Submission on the Supplementary Landscape Visual
Assessment by Michael Graham and the Master Land Use
Consent granted for the Kinloch Golf Course in 2003

Re Application by Seven Oaks Kinloch Limited for land use
consent (RM240388), subdivision consent (RM240389) and
variation to subdivision consent (RM200118B)

D Bruce Campbell, Kinloch Residential Ratepayer

20th September 2025

LOCHRIDGE ESTATE

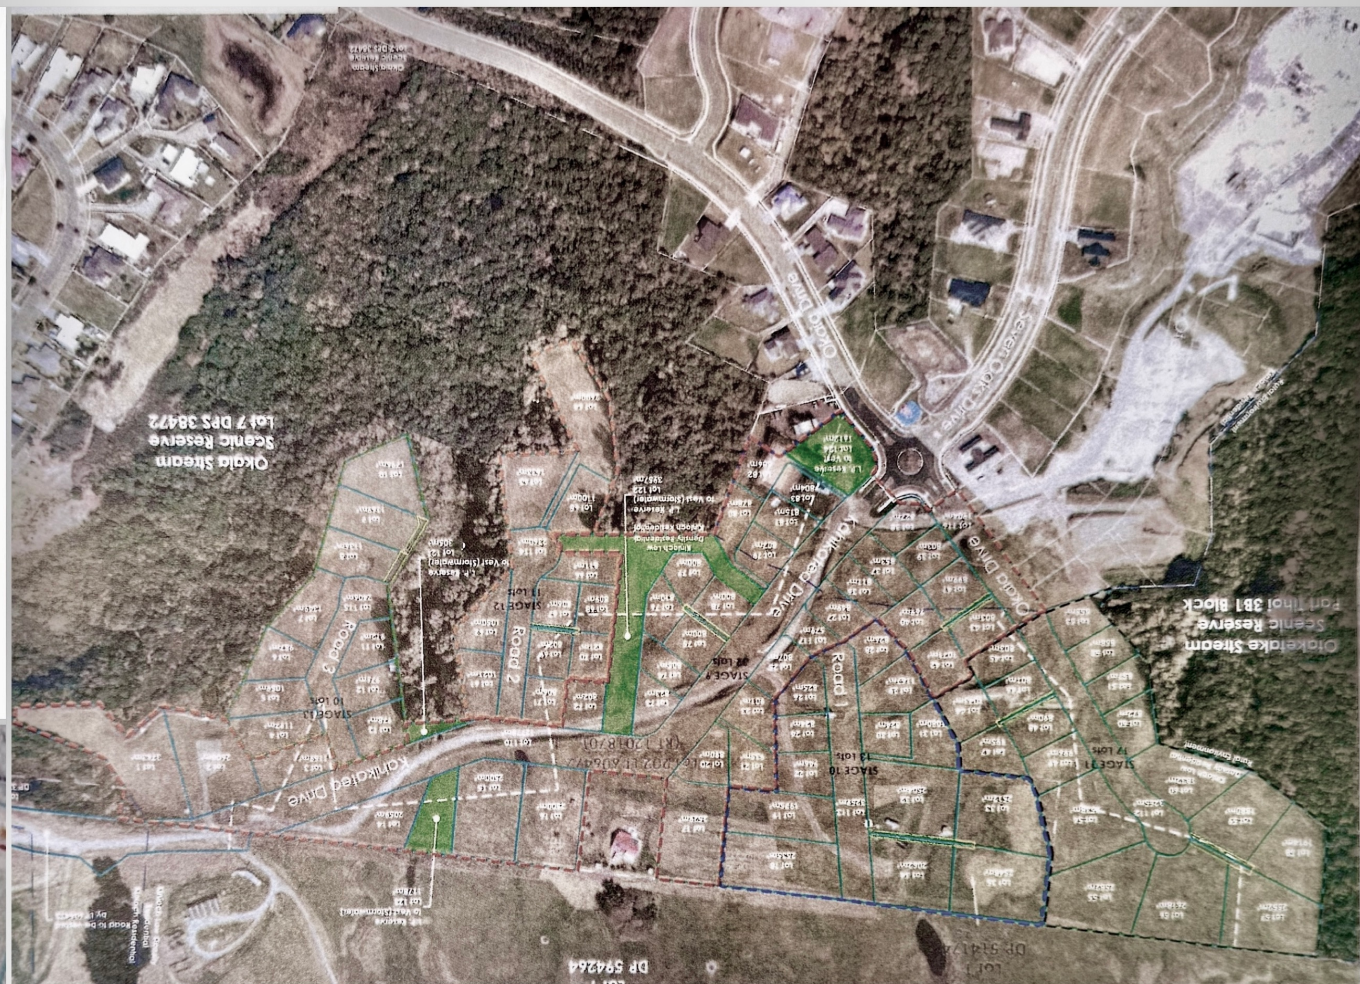
3. Mr Graham has been selective in the position he chose to take his photographic perspective, which is at a lower level than my own photograph. **Please see Appendix 2 – my view location map** My view location is Lot 22 while Mr Graham's View Location is taken from Lot 12

The 'birdseye' view shown as **Appendix 2** shows the shelter belt insitu.
